Planning Commission Staff Report

Petition: **P.Z. 13-2023 17551, 17555 & 17599 Chesterfield Airport Rd. (Baldrige-Ryken, LLC):** A request for an ordinance amendment to create a new “PC” Planned Commercial District for three parcels zoned “PC” Planned Commercial and “NU” Non-Urban and totaling 2.9 acres located on the north side of Chesterfield Airport Road, east of Long Road (17U140252, 17U140263, and 17U140203).

RE: P.Z. 13-2023 Simply Storage (17551, 17555, 17599 Chesterfield Airport Road)
(Stock Project No. 222-7350)

Figure 4: Preliminary Development Plan

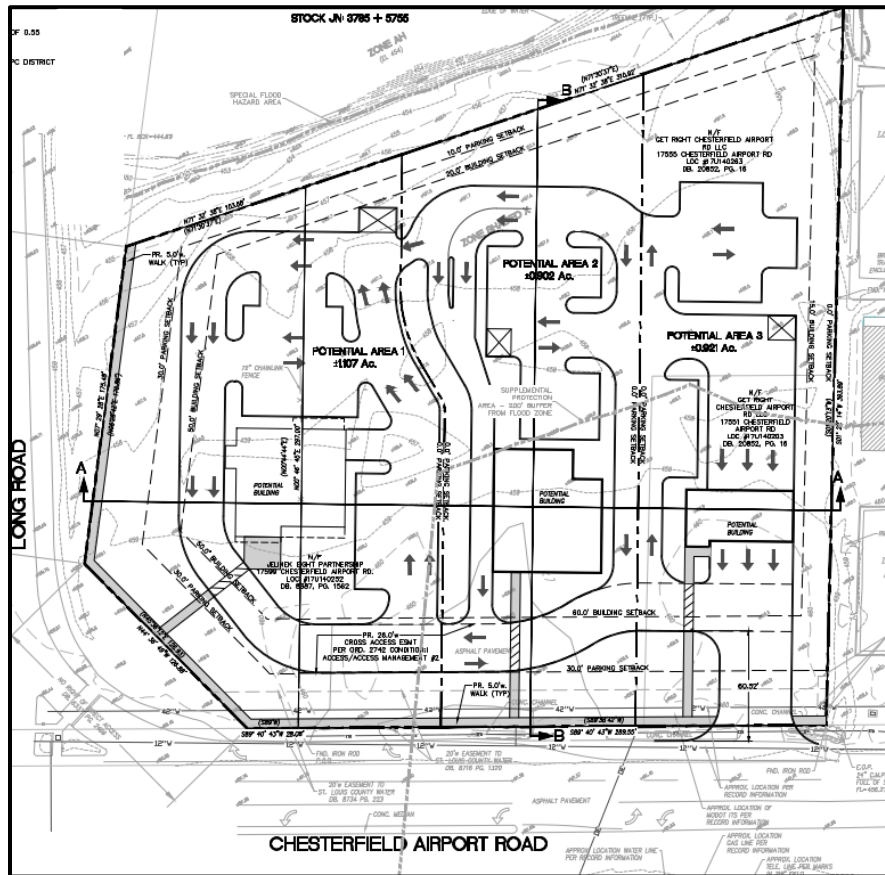
Concerns were raised regarding the proposed zero (0) feet parking setbacks for potential lots one (1) and two (2). Provide an explanation for requesting the proposed parking setbacks.

Concern was raised regarding the traffic to be generated by the potential intensity of having multiple drive-thru facilities. Provide information on how the development team will be addressing this concern.

Response: This development is intended to be three (3) different businesses sharing drives and parking access. The zero (0) feet internal lot line setback is common with many City Developments.

Response: Applicant updated the "Preliminary Development Plan" to address vehicular circulation.
